# TECHNICAL BULLETIN

MODEL/DERIVATIVE:  
Freelander

Bulletin N°: 0017  
CDS. ref: L8626bu  
Issue: 1  
Date: 07.02.01

### KNOCKING NOISE FROM STEERING WHEEL AREA

1

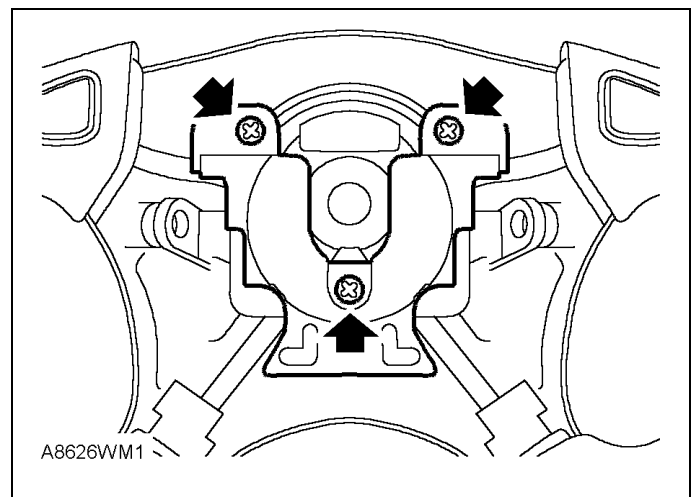
Vibration mass damper, mounted in the steering wheel, contacts fixing on underside of airbag.

1. Remove drivers airbag, Workshop Manual repair number [76.74.01](#) refers.
2. Referring to illustration 1, remove 3 screws securing damper to steering wheel and remove damper.
3. Referring to illustration 2, mark out the damper as shown, measuring 3mm either side of the right angle section.
4. Remove the shaded portion of material to produce a 45° chamfer.

Refer to the following procedure to remove material from mass damper and relieve foul condition.
